ANN ARBOR HISTORIC DISTRICT COMMISSION

Staff Report

ADDRESS: 520 Sixth Street, Application Number HDC21-206

REVIEW COMMITTEE DATE: Tuesday, July 6, 2021

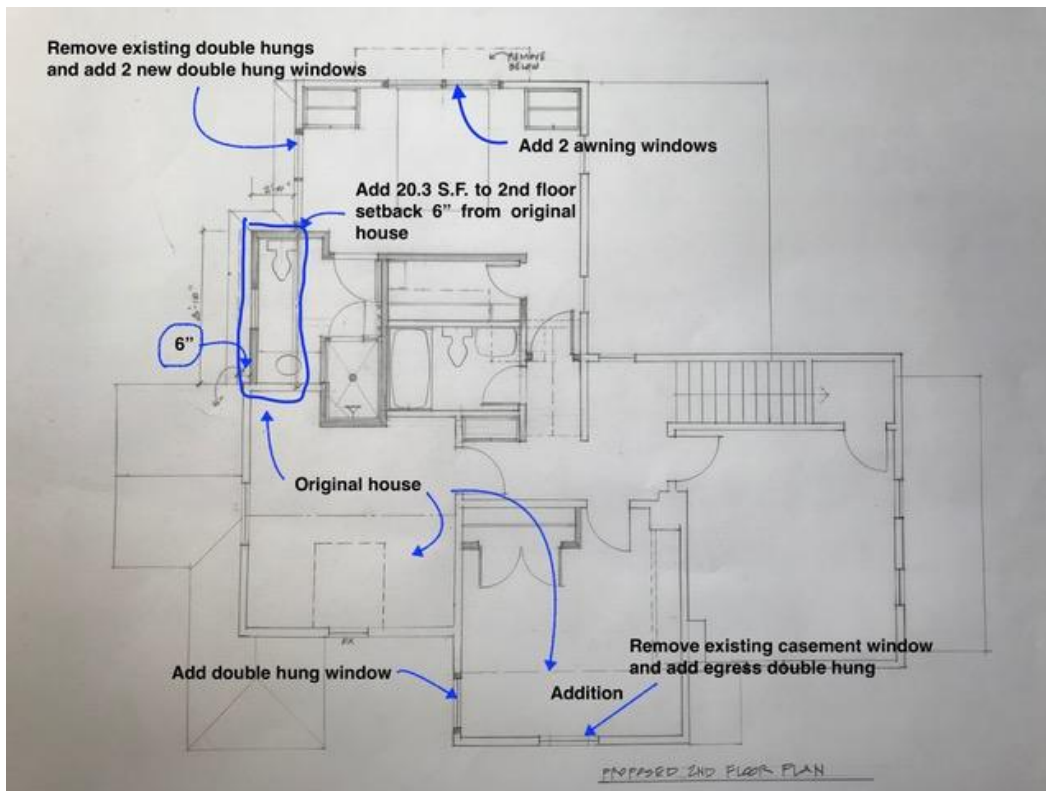
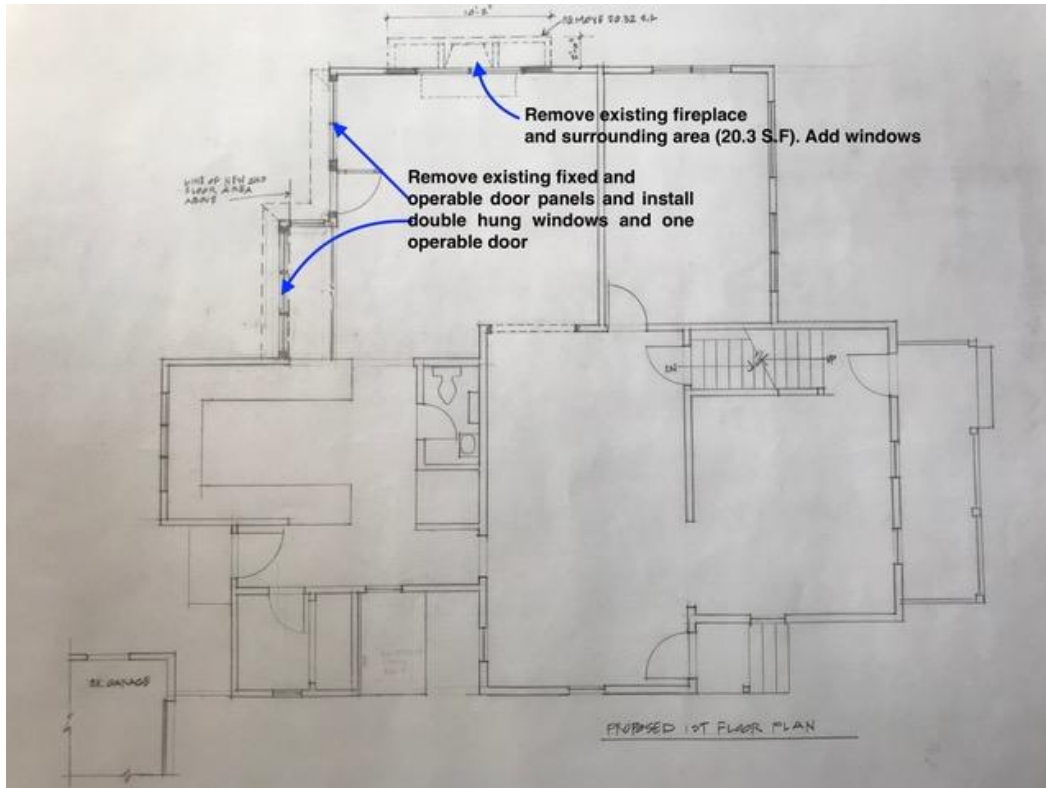
In the renovation, we would be trading out the first floor north facing fireplace bump out (20.3 SF) for the second floor addition over the leaking door wall area (20.3 SF). See floor plans below that show the first floor demo and where we'd be adding that traded space onto the second floor.

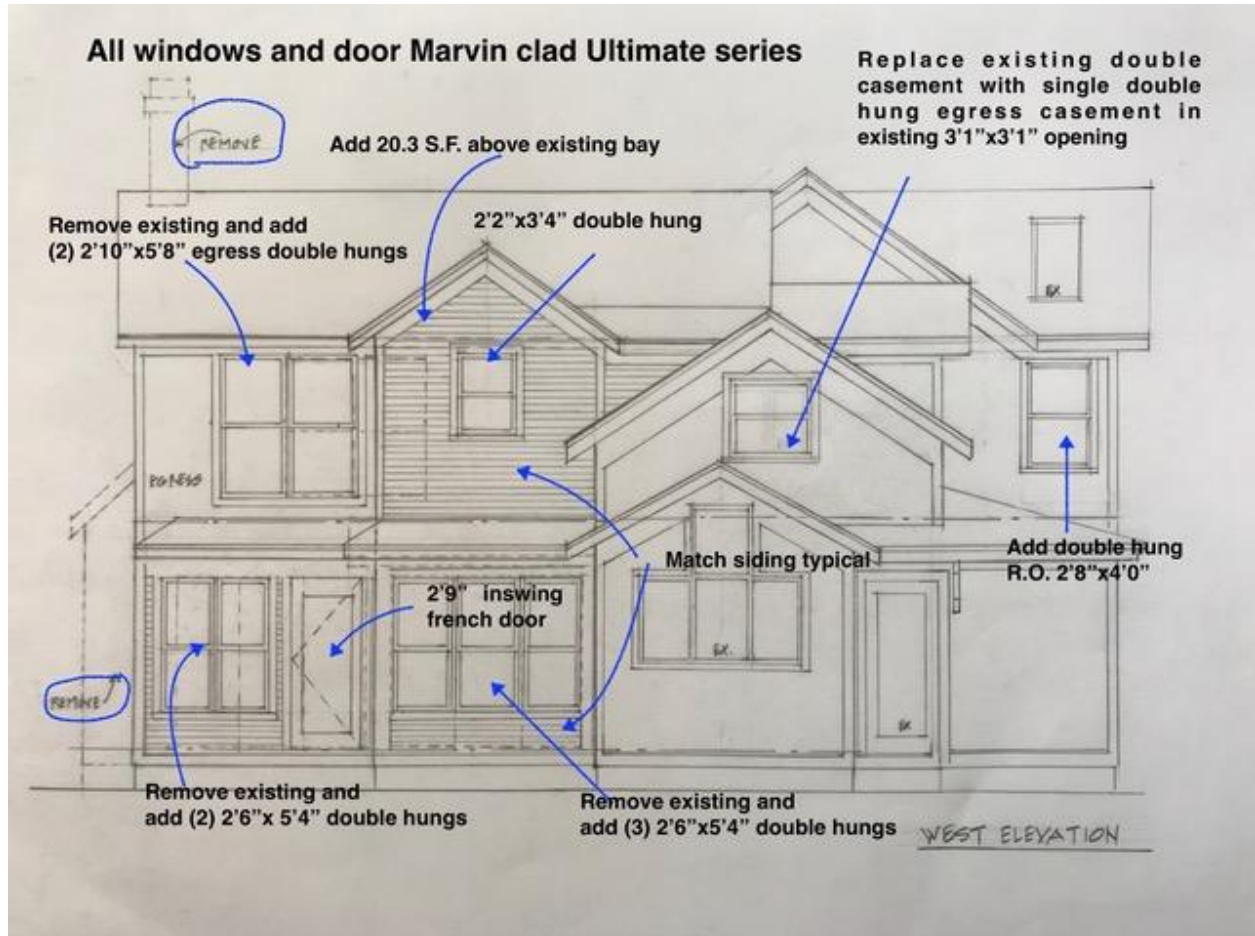
West Elevation: We plan on replacing all of the rotting doors lining the west facing part of the house (all part of the 1990's addition) and replace with double hung windows and one door for access to the deck. We will also be replacing the existing NW 2nd floor windows (part of the 1990's addition) and adding a double hung window to the SW bedroom (part of a 2000 addition).

The only historic/original area of the house where we are requesting a change, is to replace a casement window (which may have replaced an original in the 2000's), in the southwest wing on the second floor with a single double hung egress casement. Here's the drawing of what this would look like.
